CONSULTANT:		CONSULTANT:		ARCHITECT/ENGINEERS:		Drawing Title EXTERIOR ELEVATIONS		Project Title COMMUNITY LIVING CENTER		Project Number 442-12-357		Office of Construction and Facilities Management	
						<div><div>15031 SOUTH PINE BLVD SUITE 200 PARKER, COLORADO 80138 PH: 303-841-9922 WWW.AES-GFP.COM</div></div>				Building Number COWBOY					
RFI #5		21 APRIL 2017						Approved: Project Director		Location CHEYENNE, WYOMING		Drawing Number			
RFI #4		12 APRIL 2017						SYLVIE RUPP - CFM DIRECTOR				AE201			
RFI #3		31 MARCH 2017						FACILITIES/ENGINEERING		Date		Checked			
RFI #2		24 MARCH 2017						PHONE: 307-778-7550x7267		MARCH 2017		DHH			
REQUEST FOR INFORMATION #1 (RFI #1)		16 MARCH 2017						FAX: 307-287-9725		Drawn		JTB			
Revisions:		Date										Dwg. of		 Department of Veterans Affairs

RFI #5	21 APRIL 2017
RFI #4	12 APRIL 2017
RFI #3	31 MARCH 2017
RFI #2	24 MARCH 2017
REQUEST FOR INFORMATION #1 (RFI #1)	16 MARCH 2017
Revisions:	Date

Project Title
COMMUNITY LIVING CENTER

4 SOUTH ELEVATION AT SOUTH WING
1/8" = 1'-0"

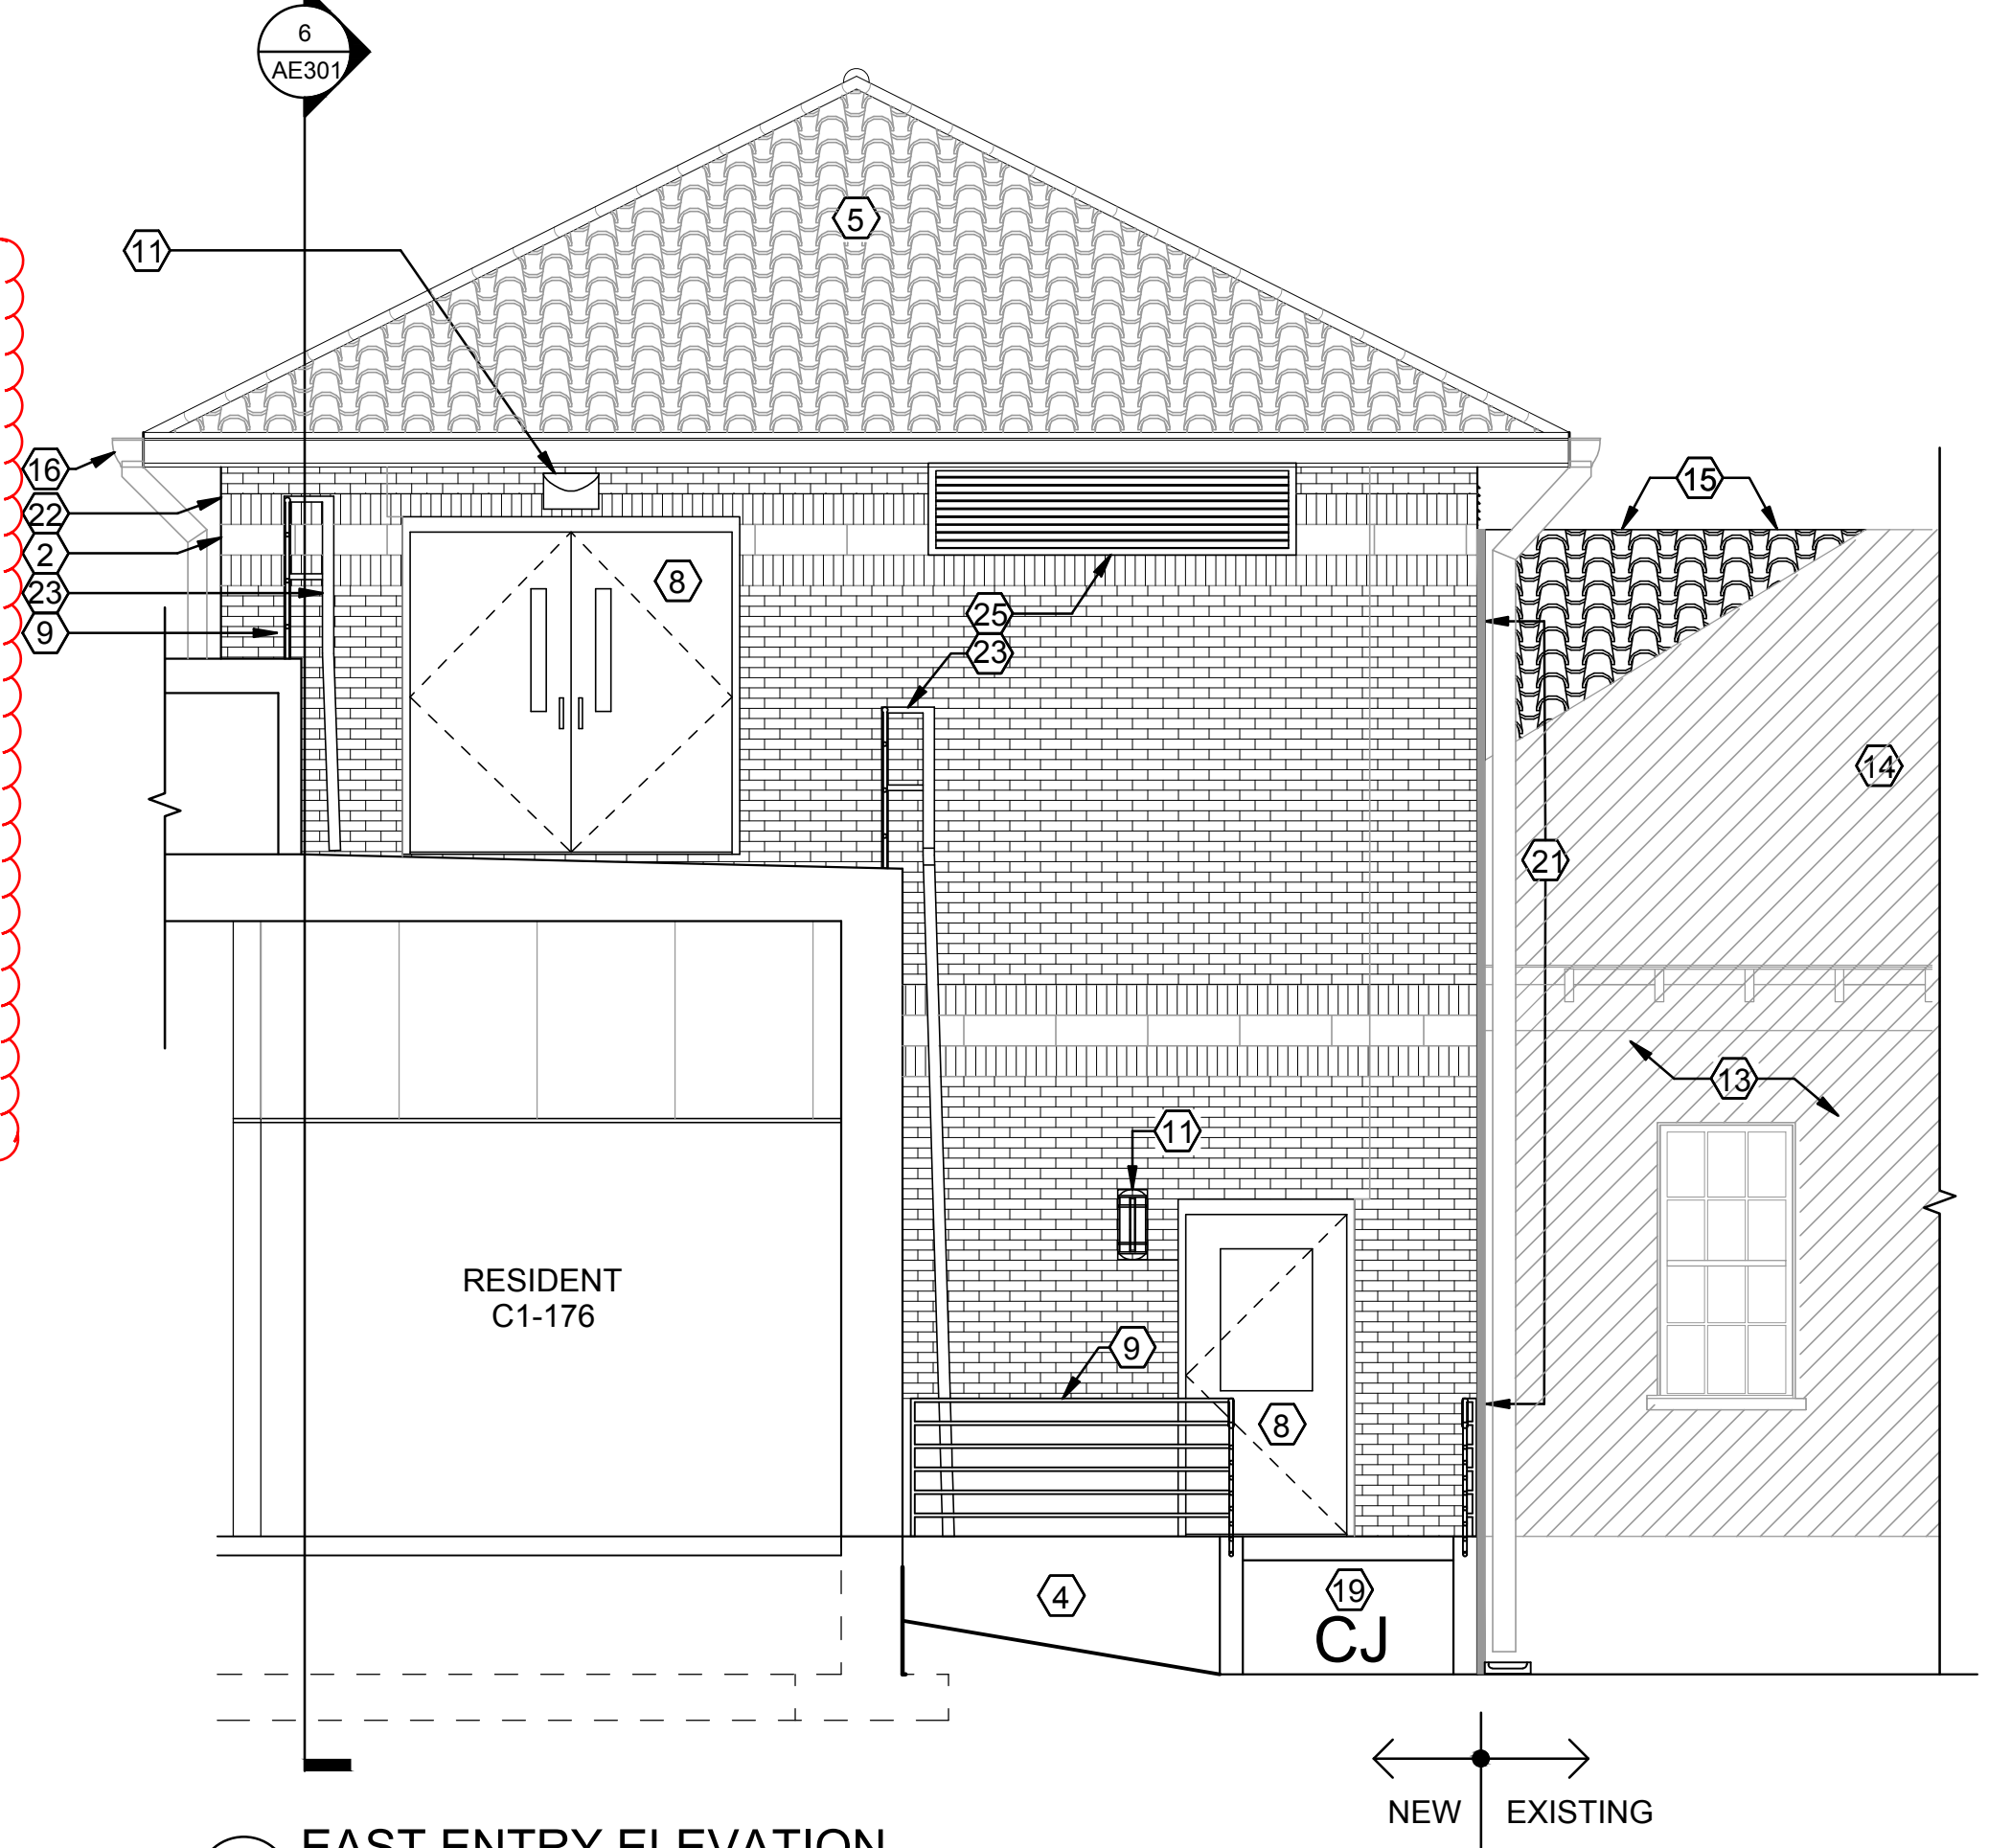
ADJUSTMENT TO SEVERAL CONTROL JOINTS (CJ)
